Technical Service Information

THM 4L60 (700-R4) LONG LIP SEALS ARE BACK

Figure 1

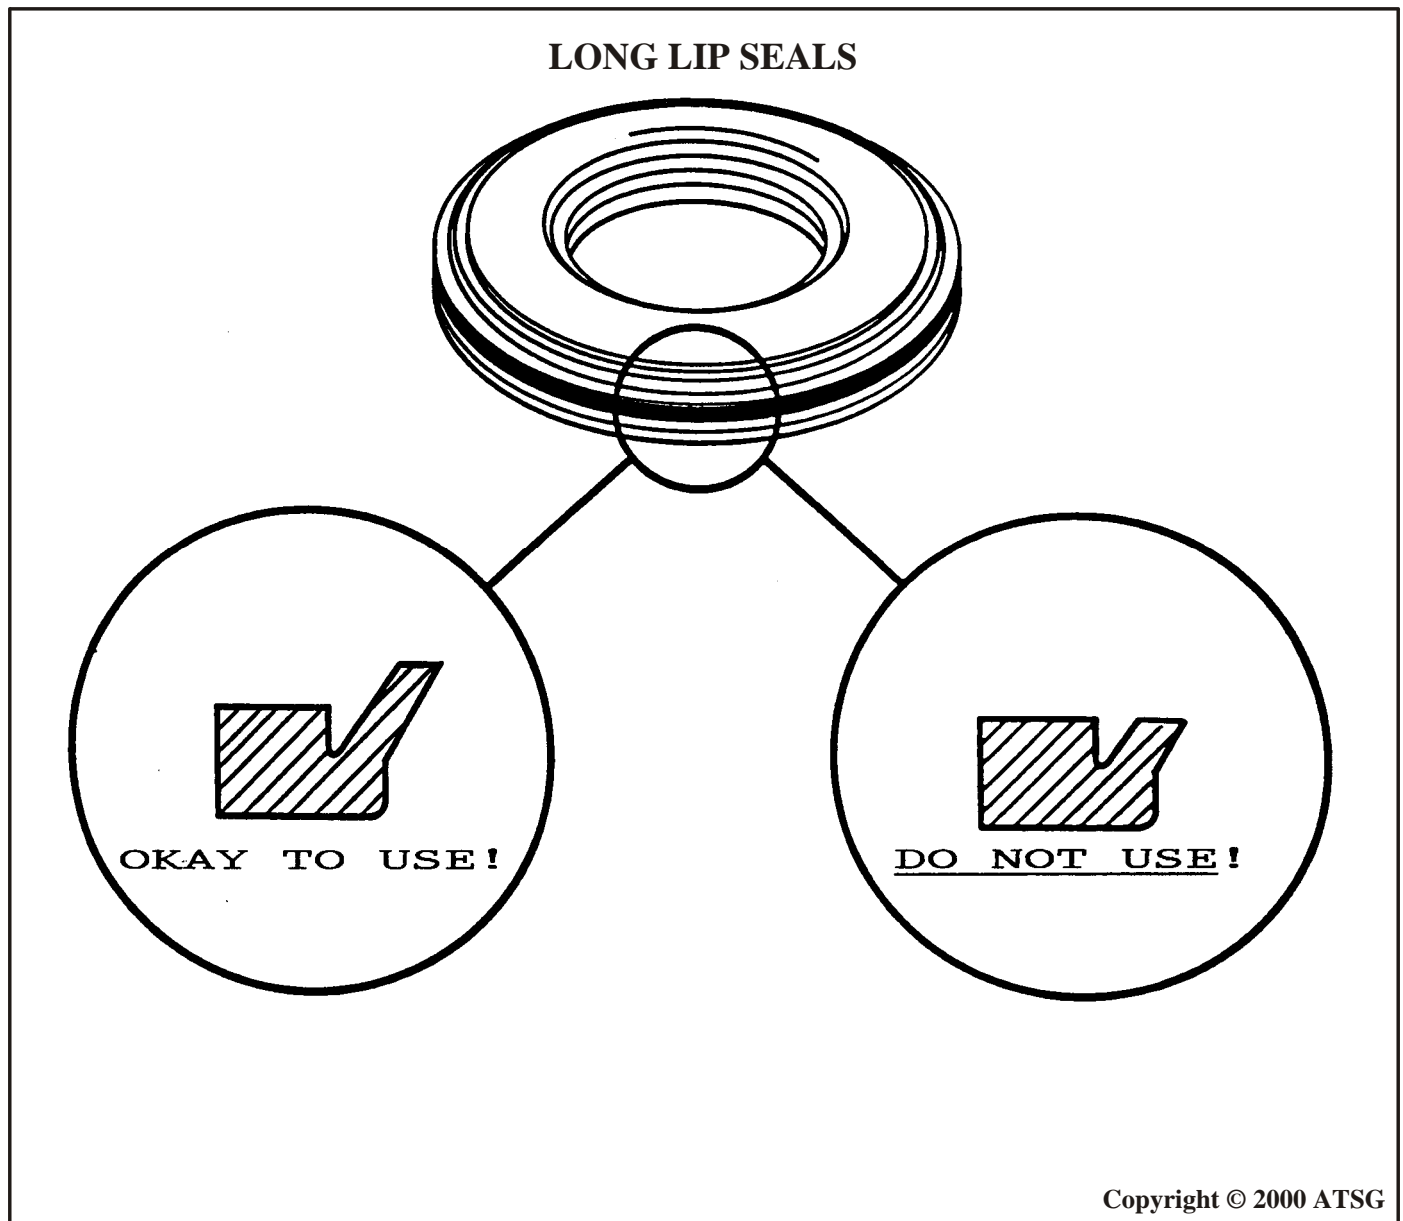
Beginning at the start of production 1994, the manufacturer is once again using "Long Lip Seals" in the outer locations on all THM 4L60-E transmissions. This is being done as "Running Changes" through 1994, and apply to the following:

- 1 REVERSE INPUT CLUTCH OUTER
- 2 3-4 CLUTCH OUTER
- 3 FORWARD CLUTCH OUTER
- 4 OVERRUN CLUTCH OUTER

Please specify "Long Lip Seals" when ordering gasket and seal kits from your supplier for all THM 4L60 and 4L60-E transmissions.
